NJT: Compartment Door Hinge Replacement

Property name and Top bus number: NJT - 305000

Issue: Compartment door hinges may be incorrect on some units / paint on hinge “pins” causing the hinges to seize over time

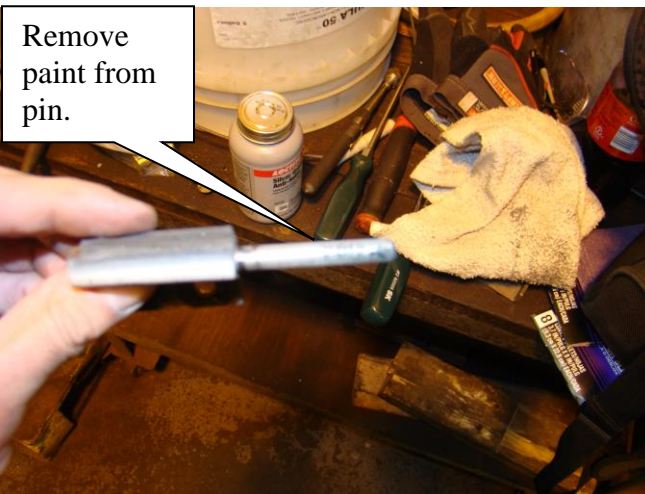
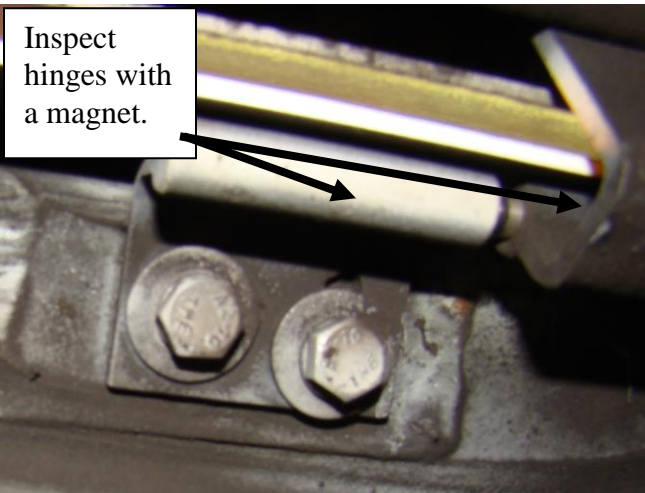
1. Park the bus and apply the parking brake.
2. Turn off main battery disconnect switch(es).
3. Locate the access doors that need the hinges to be inspected/repaired (see below).

4. Inspect the access door hinges with a magnet to verify that they are stainless steel or steel hinges (Steel hinges must be replaced with stainless steel hinges). Remove bolts from hinge bracket attached to the bus. Remove the gas springs from the door. Unbolt the hinges from the door and install the new hinges as required. If the hinges are correct, the hinge pins need to be removed and the paint needs to be removed from the hinge pins (see below). Reinstall door reusing the existing hardware and adjust accordingly. Do this for every door except the radiator door.

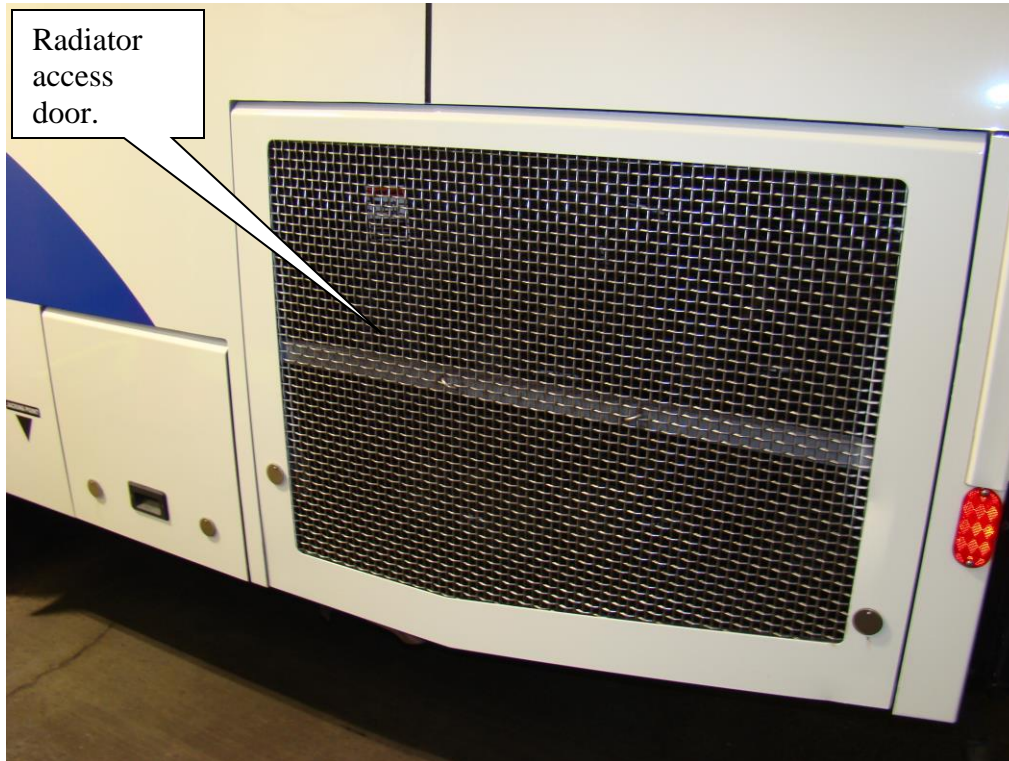
IMPORTANT: When reinstalling the hinges it is very important that the doors are properly aligned with the body of the bus or damage to the doors and/or the body of the bus may occur. Note any body damage from previously mis-aligned panels.

5. Use the same steps as performed in step 4 for the radiator access door however if the door side hinges need to be replaced the screen on the radiator door must be removed in order to replace hinge. Drill out the 15 rivets in order to remove the screen for the door. After replacing the hinge reinstall screen using rivet PN: 2406RHSS04 (3/16 x 1/4").
